LZ Fashion Wear Ltd

Plot # 154, DEPZ (Ext.), Ganakbari, Savar, Dhaka
(23.943990,90.280182)

14th March 2015

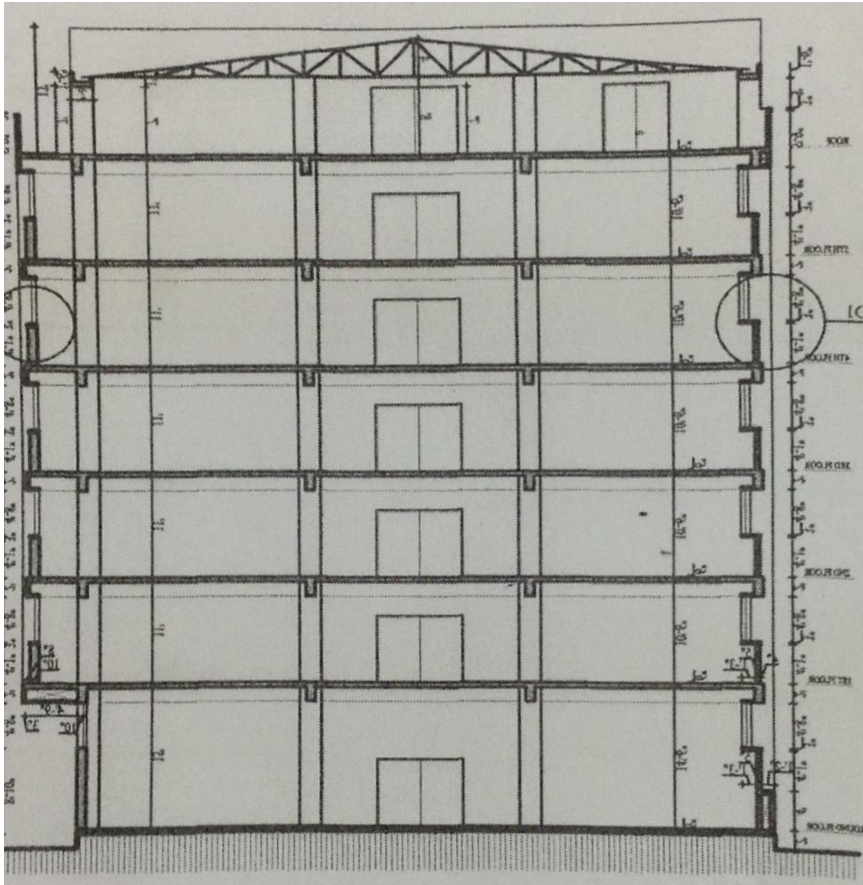
The holes appears to have been relocated into the adjacent slab. If holes did exist in the beams there would be significant questions regarding the strength of the slab and the stability system.

Discrepancies between architectural drawings and on-site observations

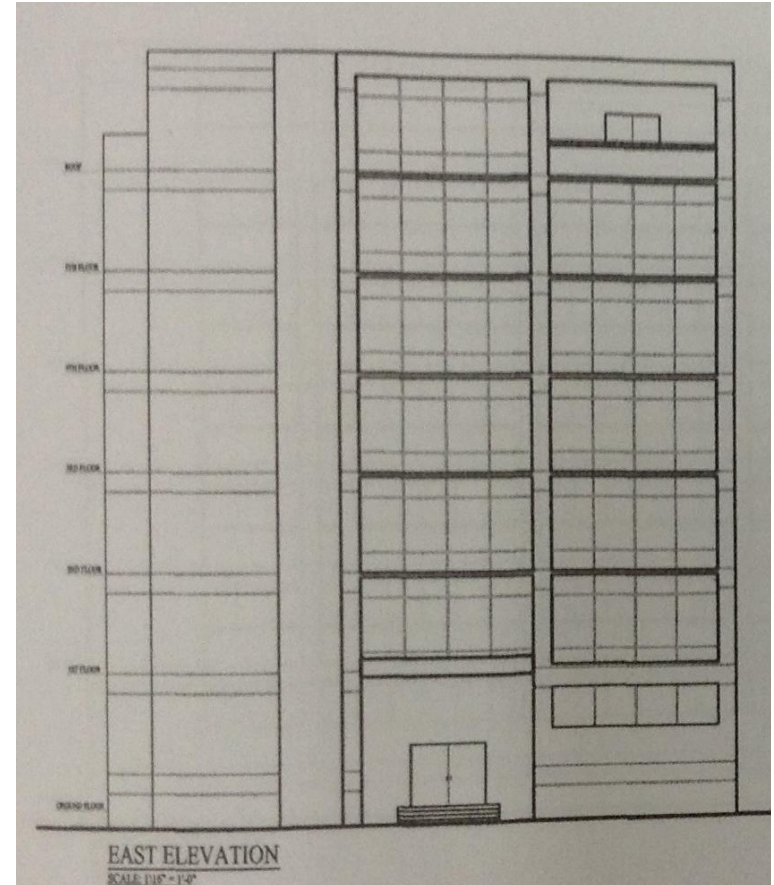
Steel roof structure replaced with concrete

South cantilever missing off elevations

Item No.	Observation	Recommended Action Plan	Recommended Timeline
1	Discrepancy between structural drawings and on-site observations	Update structural drawings to reflect as-built condition	6-months
2	Discrepancies between architectural drawings and on-site observations	Update architectural drawings to reflect as-built condition	6-months
